49 CFR Part 571

[Docket No. NHTSA-2026-0001]

Federal Motor Vehicle Safety Standards: Anti-Ejection Glazing for Bus Portals; Mandatory Applicability Beginning October 30, 2027

ACTION: Final rule; partial grant of a petition for reconsideration.

Figure 1 to 49 CFR 571.217a—Guided Impactor

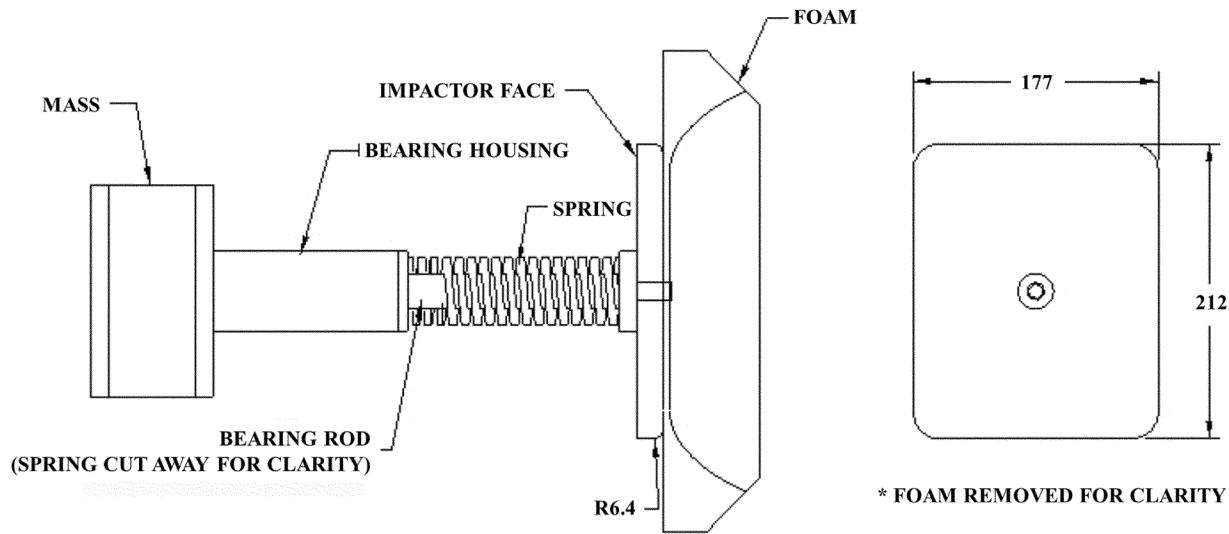
The second correction is in the figures in the regulatory text of the standard. As IC Bus noted, the figure numbers are not included in the figures. NHTSA is adding the figure numbers to those figures with this final rule.

- c. Revising the introductory text of S6.1.1;
- d. Revising Figure 1 and Figure 2; and
- e. Adding Figure 3.

Figure 3 to 49 CFR 571.217a—An Example of a Daylight Opening Periphery (for Illustrative Purposes Only)

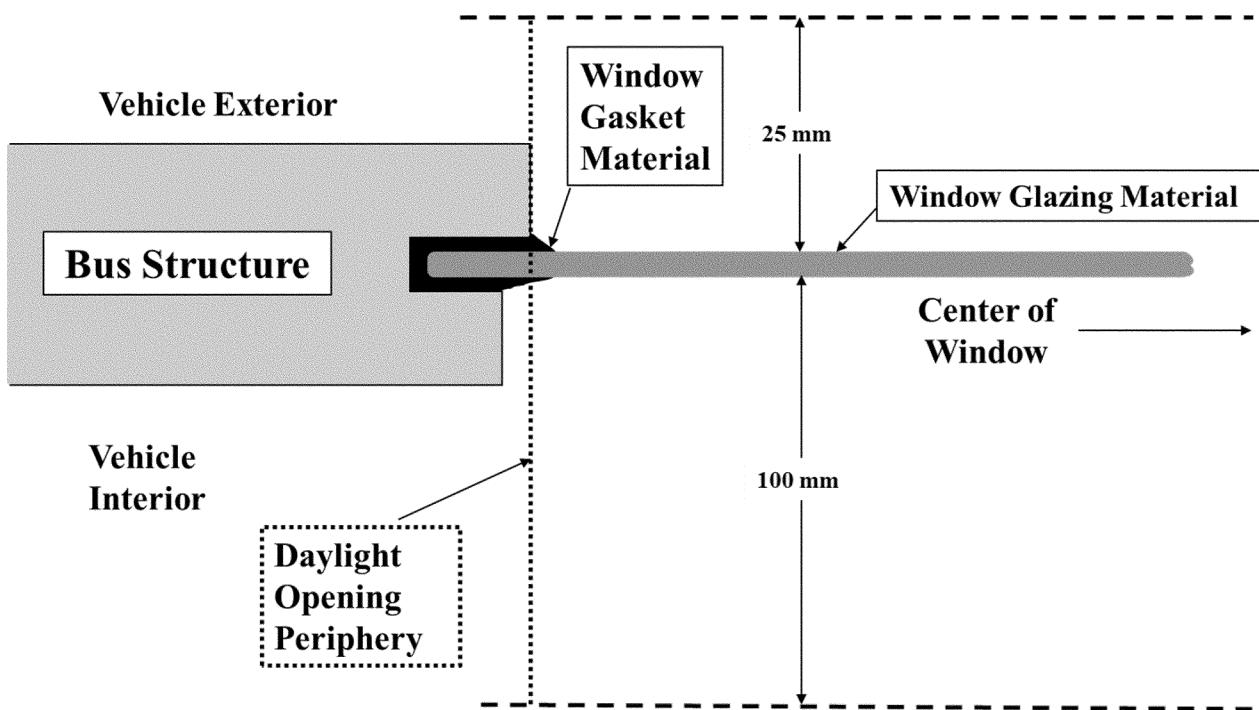
Next, IC Bus requested that Figure 7 in the Technical Support Document,⁹ which was submitted to the docket with the FMVSS No. 217a final rule, be included in the standard. The purpose of that figure and the Technical Support Document was to provide helpful context and examples for aspects of the final rule. This supplemental document and the figures within it will remain accessible on the public docket to manufacturers or other interested parties. However, NHTSA agrees with IC Bus that the figure could be a helpful addition to the regulatory text by making it easier for manufacturers to understand how to determine the daylight opening periphery. This figure is for illustrative purposes only and does not represent all possible daylight opening configurations. Therefore, NHTSA is adding the figure to the regulatory text and amending the definition of “daylight opening” to include the following sentence: “An example of a daylight opening periphery is provided in Figure 3 for illustrative purposes only.”

Daylight opening means, for openings on the side of the vehicle (other than a door opening), the locus of all points where a horizontal line, perpendicular to the vehicle longitudinal centerline, is tangent to the periphery of the opening. For openings on the roof of the vehicle, daylight opening means the locus of all points where a vertical line is tangent to the periphery of the opening. The periphery includes surfaces 100 millimeters (mm) inboard of the inside surface of the window glazing and 25 mm outboard of the outside surface of the window glazing. The periphery excludes the following: Any flexible gasket material or weather stripping used to create a waterproof seal between the glazing and the vehicle interior; grab handles used to facilitate occupant egress and ingress; a restraining barrier; and any part of a seat. An example of a daylight opening periphery is provided in Figure 3 for illustrative purposes only.
